Tennessee Valley Authority, 1101 Market Street, Chattanooga, TN 37402

CNL-18-015

Subject: Submittal of Revised Site Safety Analysis Report Figure 2.5.1-34 in Support of Early Site Permit Application for Clinch River Nuclear Site

**CLINCH RIVER NUCLEAR  
SITE SAFETY ANALYSIS REPORT REVISED FIGURE 2.5.1-34**

**Figure 2.5.1-34. Site Area Geologic Map**

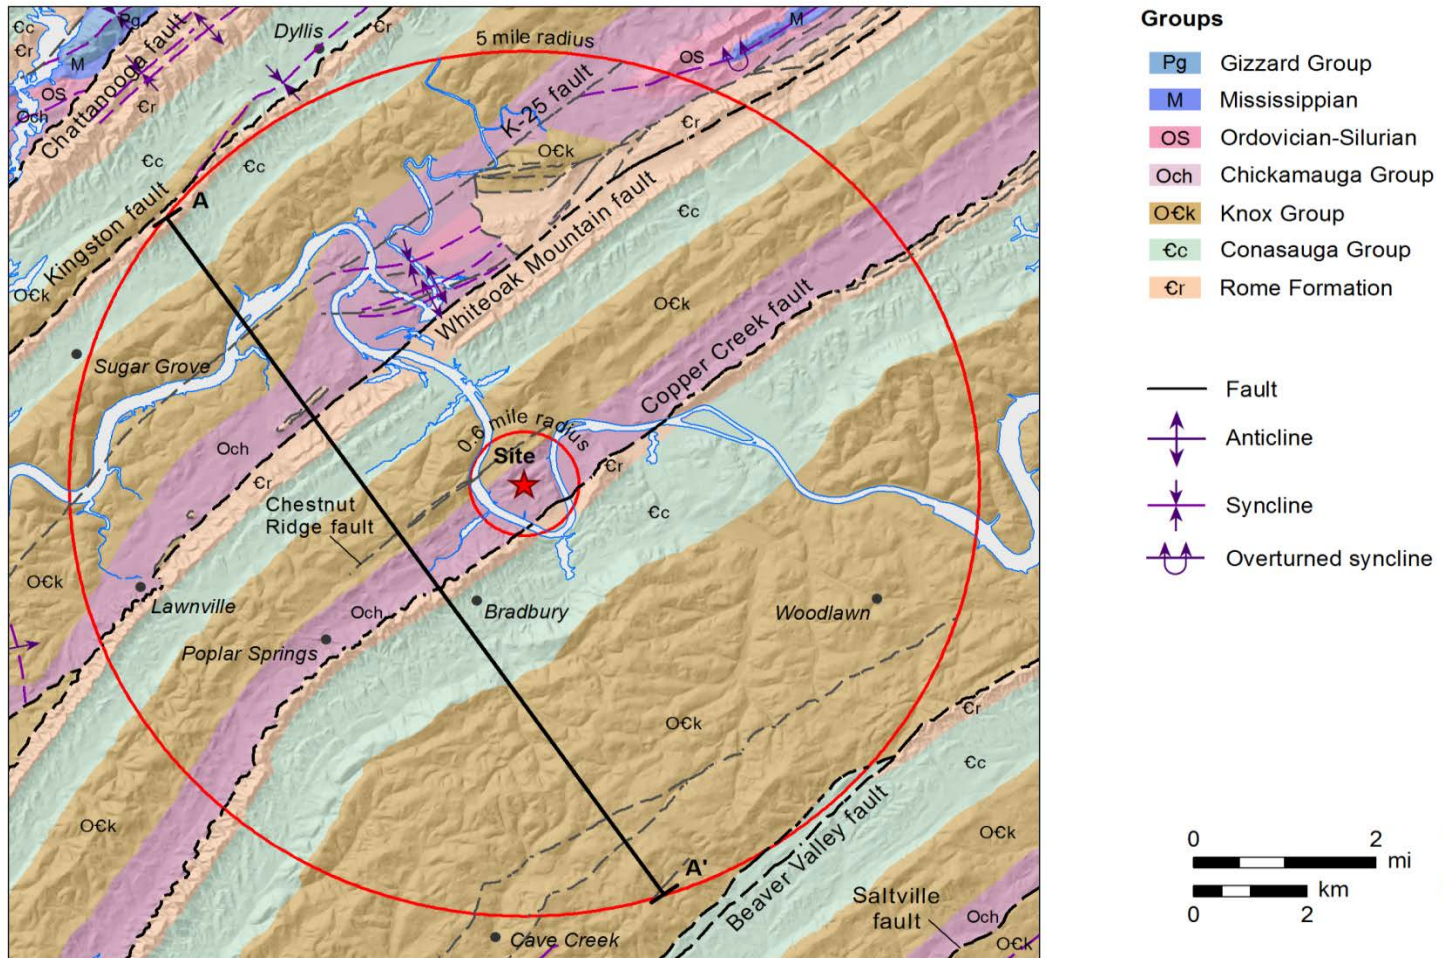
During a January 17, 2018 telephone call, the Nuclear Regulatory Commission (NRC) requested clarification on the revised Figure 2.5.1-34 submitted in Reference 2 regarding a shaded area located between the Knox Group and Chickamauga Group in the lower left quadrant of the figure. This shaded area was not indicated on the original Figure 2.5.1-34 submitted in Reference 1. Following review and comparison of the original and revised figures, it was determined the shaded area in the revised figure was unintentionally applied.

The purpose of this letter is to provide a corrected Figure 2.5.1-34 removing the shaded area in question. The corrected figure is provided in the enclosure to this letter. The corrected figure will be incorporated in a future revision of the ESP application.

SSAR Figure 2.5.1-34 is being revised and will be replaced with the following figure.
